PH APRIL 2016
REV 3

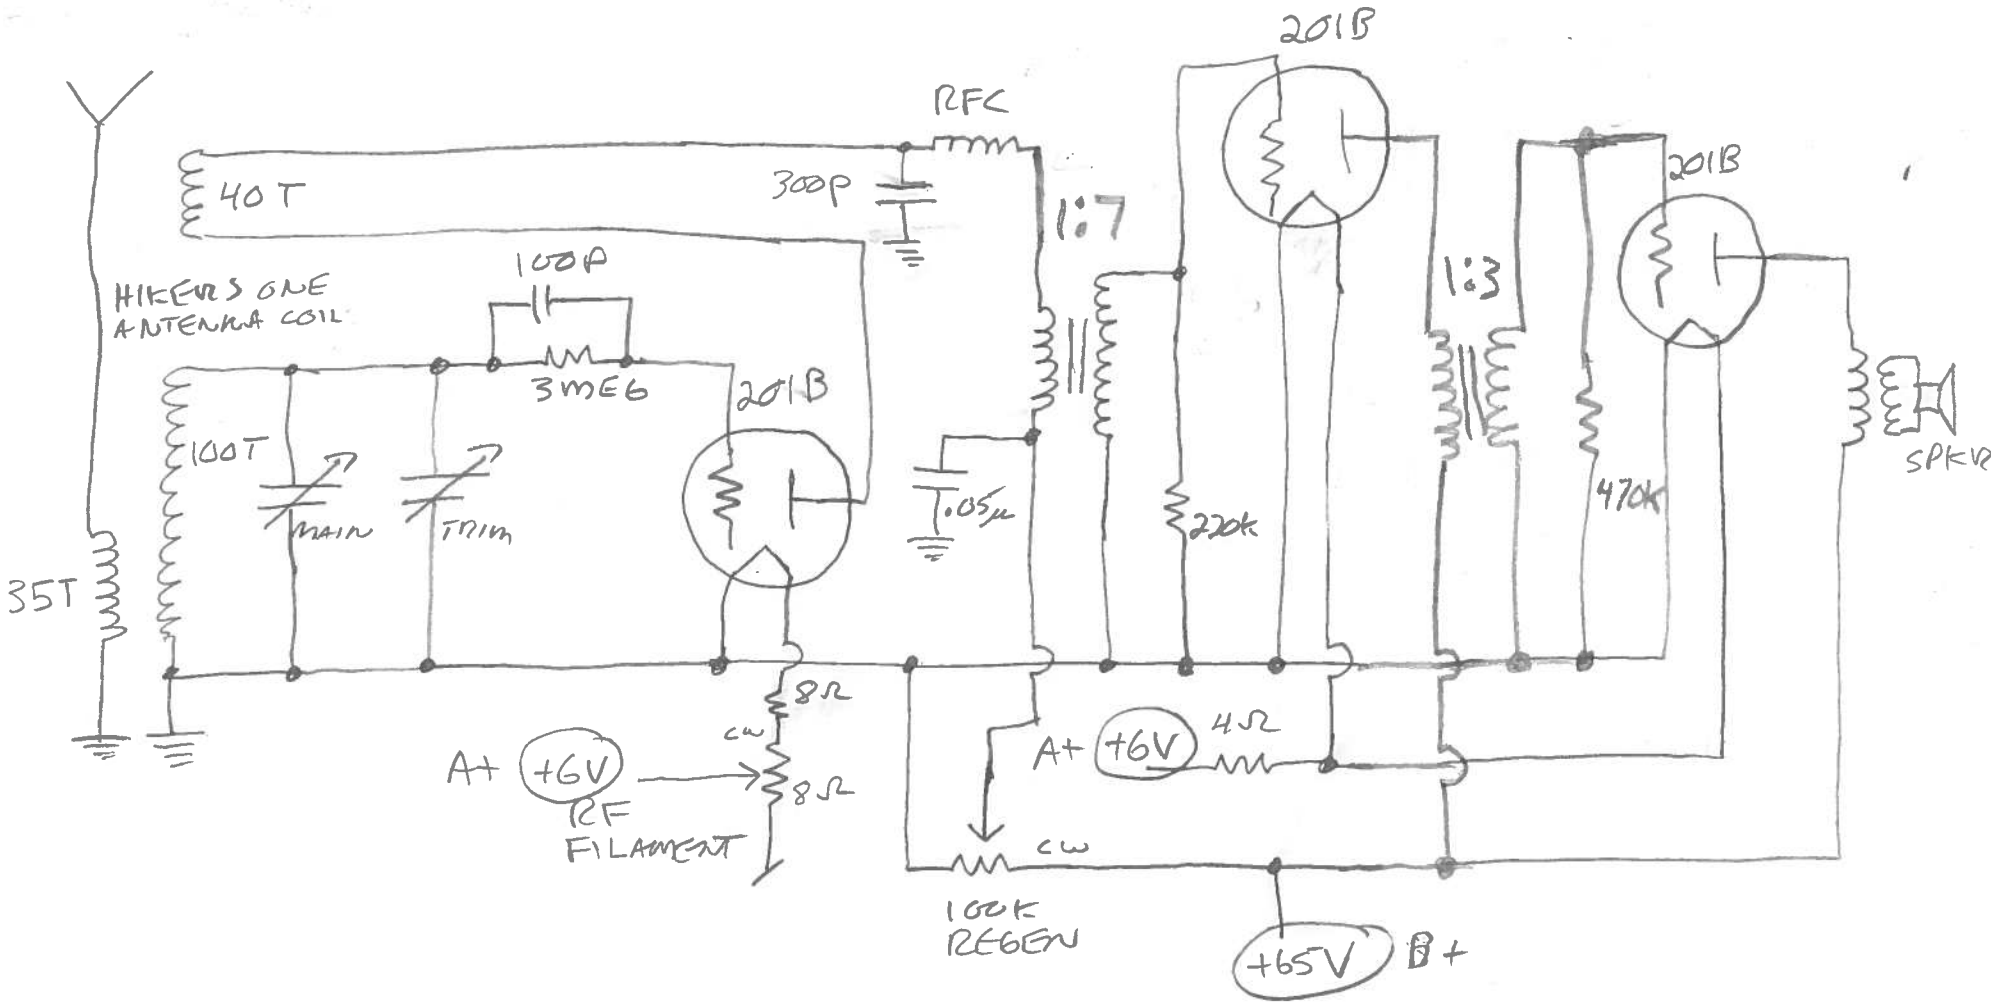
* .05μ TO BE REPLACED BY 500 SET TRANSFORMER. FOR APPROX 6 TO 8 db MORE GAIN... (TBD.)
